ADDENDUM NO. 7

Reference: Northern Utah Interagency Fire Dispatch Center
DNR – Draper, Utah
Project No.10013500

Northern Utah Interagency Fire Dispatch Center

ADDENDUM NO. # 07

EY701

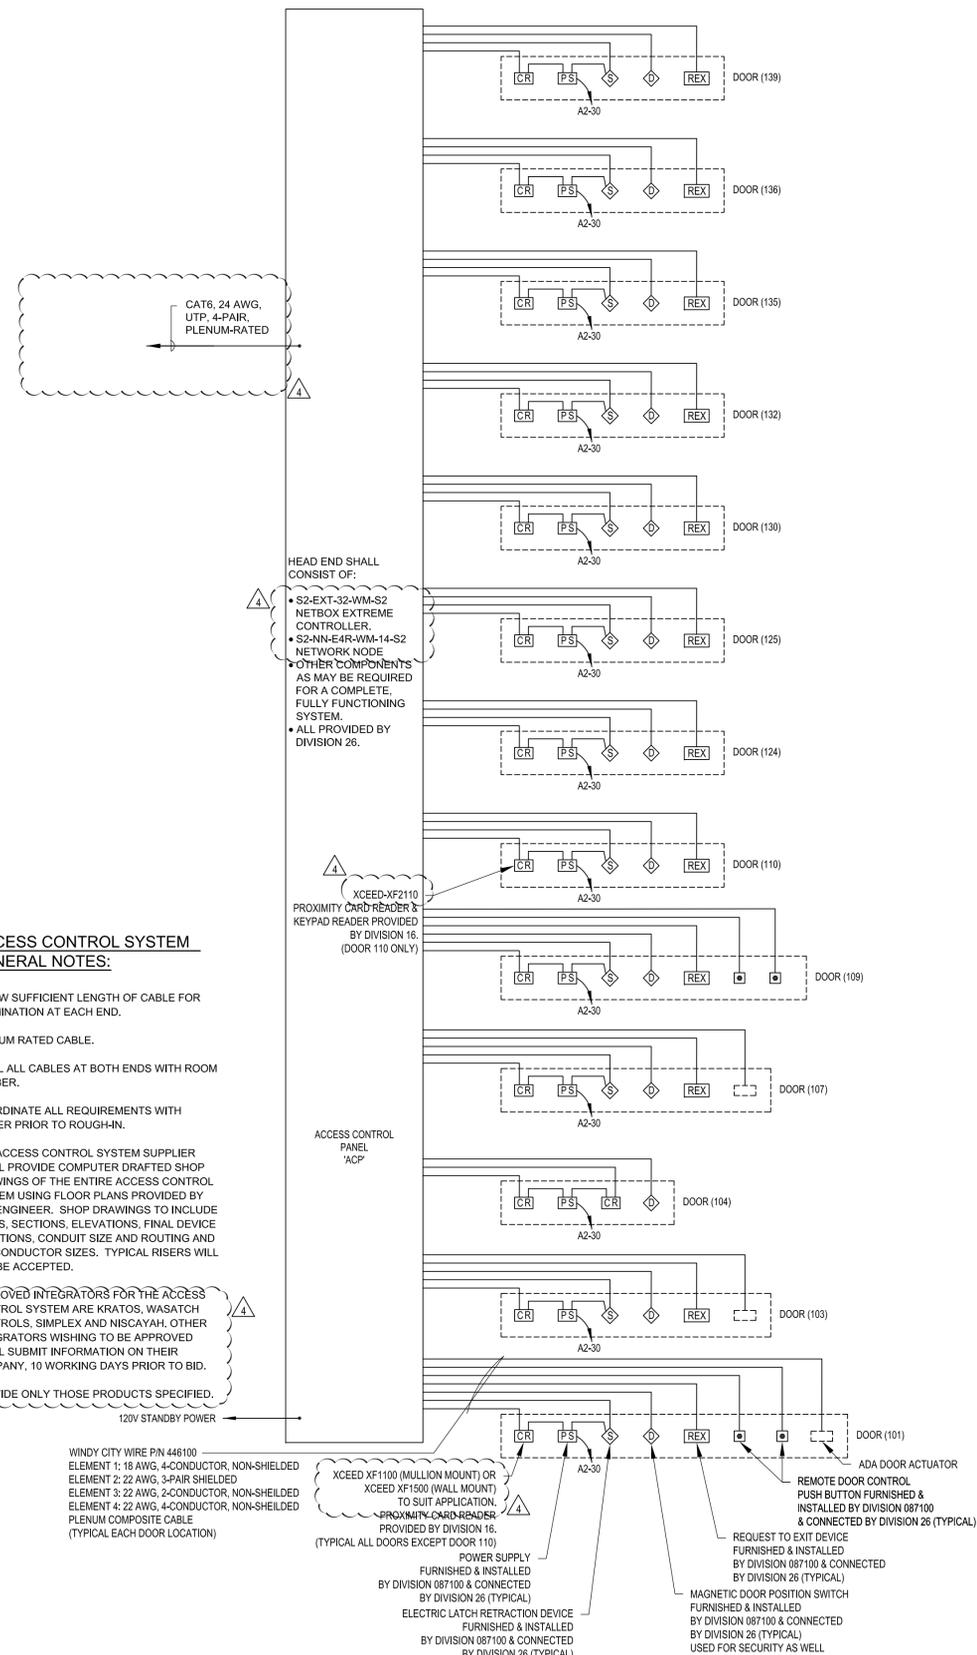
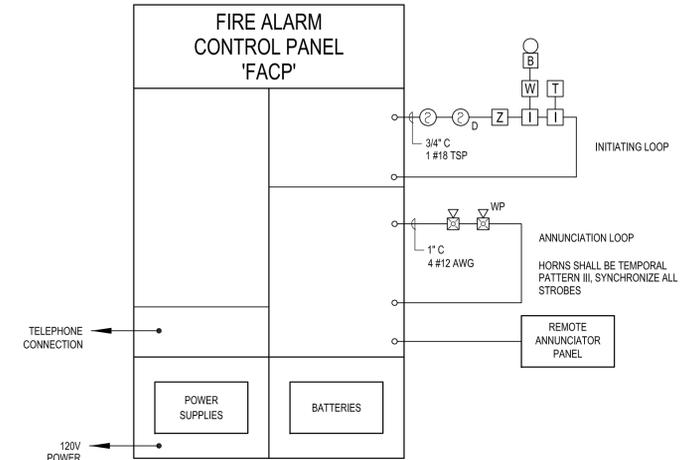
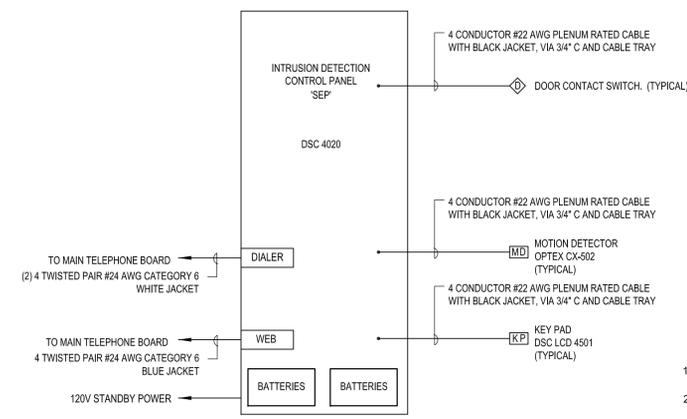
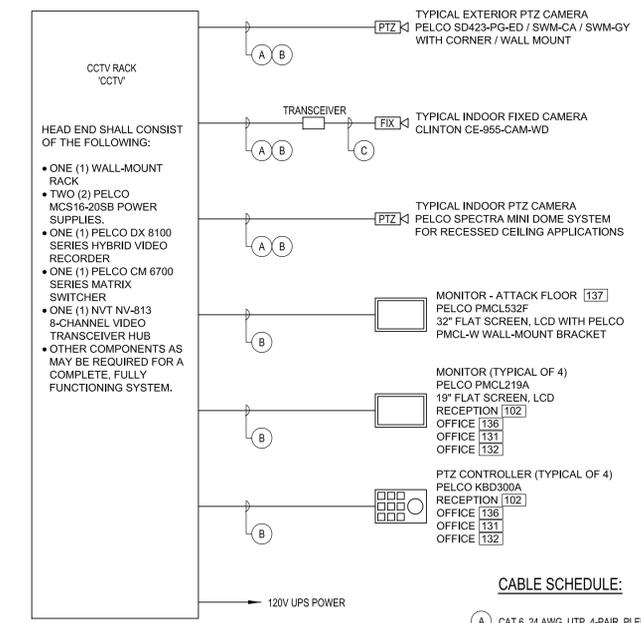
SHEET EY701: Auxiliary Risers

1. Change access control head end equipment. Refer to EY701 for clouded changes.
2. Change access control card reader type. Refer to EY701 for clouded changes.
3. Add approved integrators for access control and security systems. Refer to EY701 for clouded changes.
4. All changes associated with the S2 system have been made on drawings. No specification section changes necessary. Refer to EY701 for clouded changes.
